DESCRIPTIVE REPORT

Office No. H-9904

General Locality Chesapeake Bay Entrance

Locality Middle Ground to Nine Foot

H-9904 (H-996)
SCALE: 1:10,000

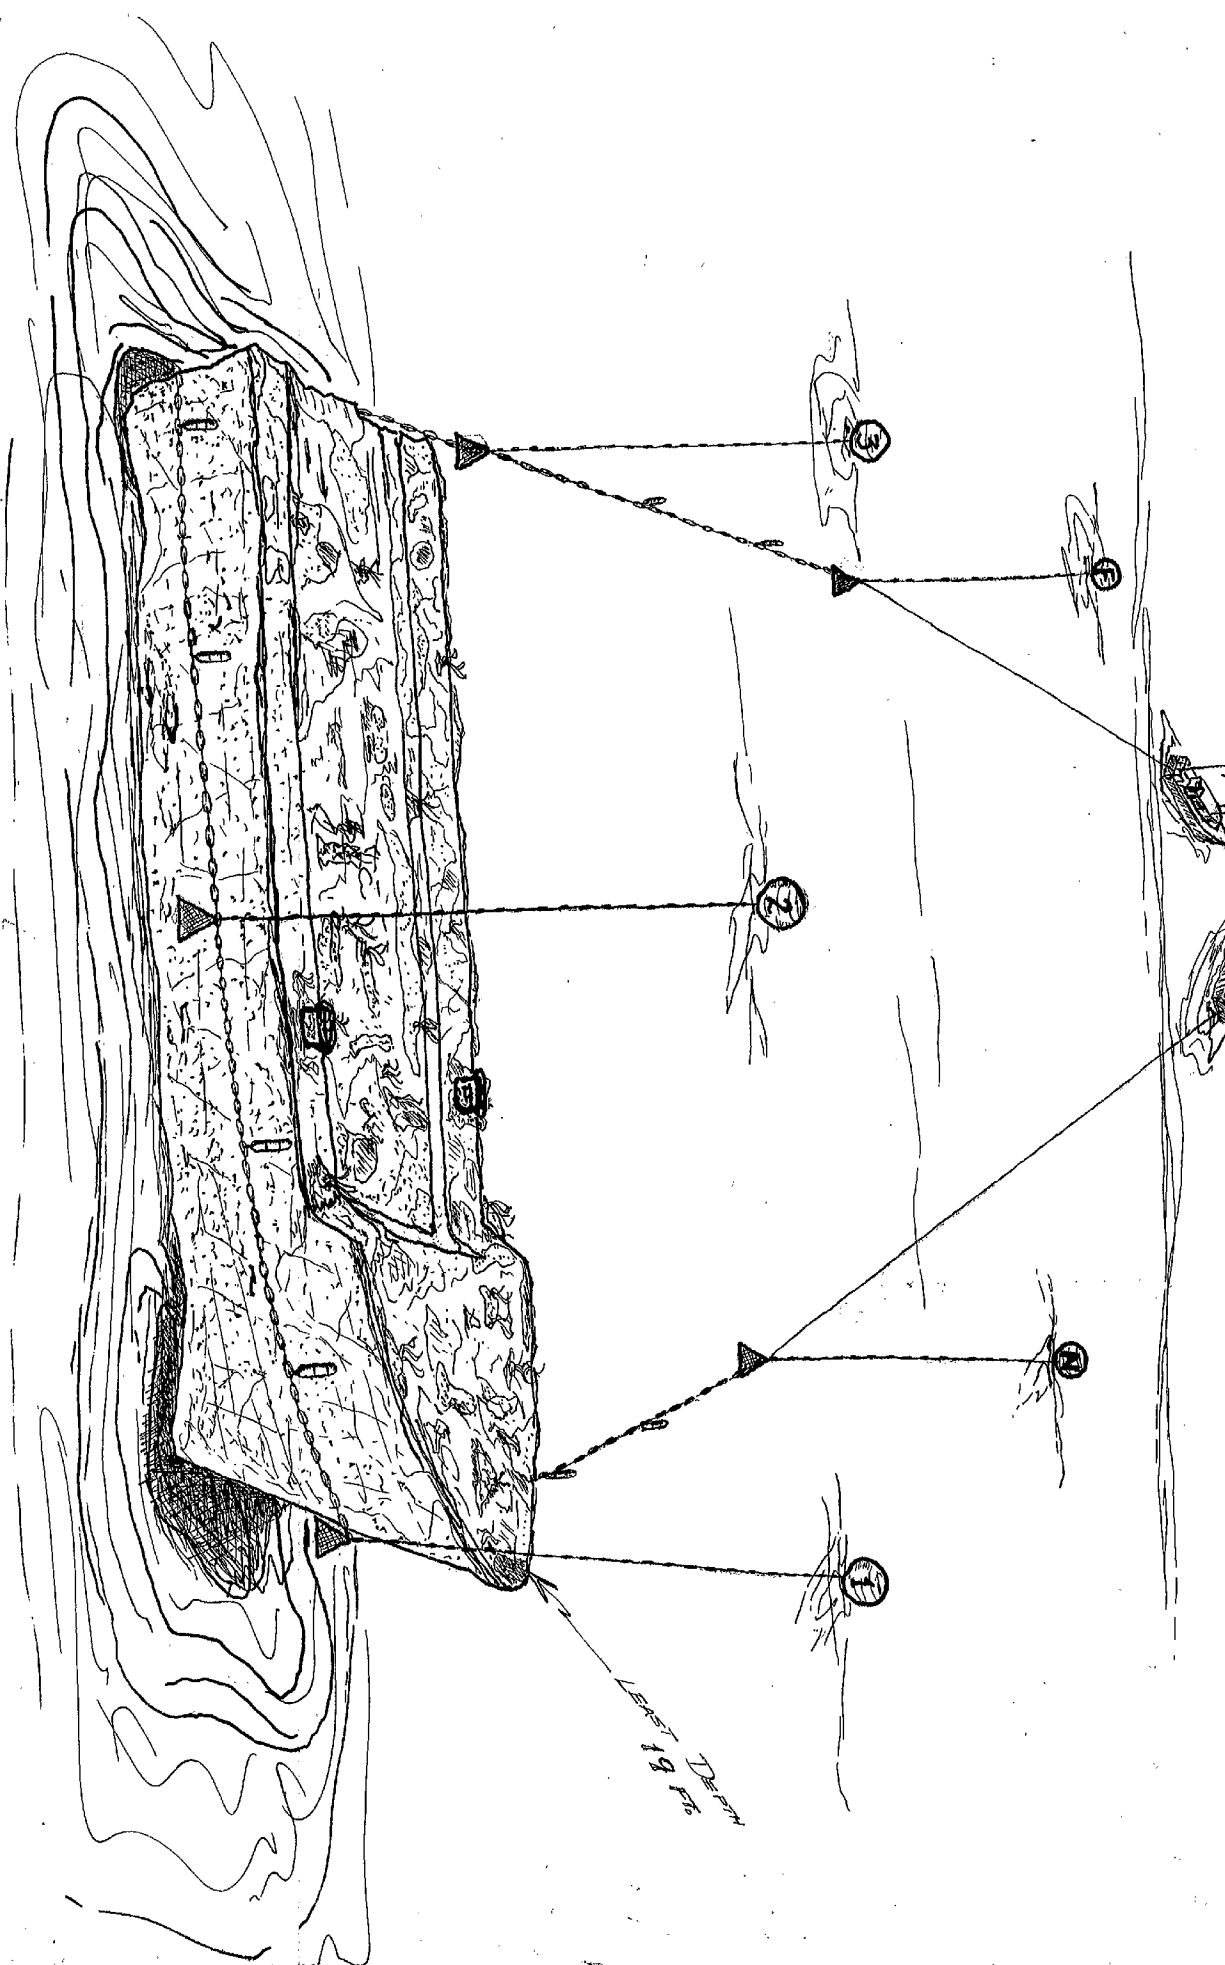
B. Recommend item remains charted as is and be considered for conventional wire drag. *Least depth and location plotted on page size sheet and inserted in this report.*
Do Not Concur - see Quality Control Report.

WRECK CLEARED BY LIFT FROM H-6438(1930) W.D.

~~WRECK~~ "ANGLO-AFRICAN"

See Quality Control Report

The dangerous sunken wreck (7 ft rep) presently charted at latitude 37°03'23"N, longitude 75°53'58"W is from a questionable echo trace at a depth of 7 feet on H-9693 (1977). The original source of the wreck was not ascertained. However, wire-drag survey H-6438 (1939) WD verified its existence at a least depth of 14 feet. The wreck was cleared by an effective drag depth of 11 feet on that survey and charted as such on chart 12221 (1222) in the early 1940's. A diver's investigation during the course of the present survey obtained a least depth of 16 feet at the wreck site. The Diver Report states, however, that a complete ascertainment of the area was not possible due to the currents and extremely limited visibility. As a result, the 14-foot depth was brought forward to the present survey from survey H-6438 during the quality control inspection. The present investigation is considered sufficient to discredit the 7-foot questionable echo trace. It is also believed that the 11-foot clearance obtained on the 1939 wire-drag survey continues to be valid. Hence, the feature should now be charted as a wreck cleared by 11 feet, located at the position found on the present survey. No further investigation of this wreck is considered necessary.
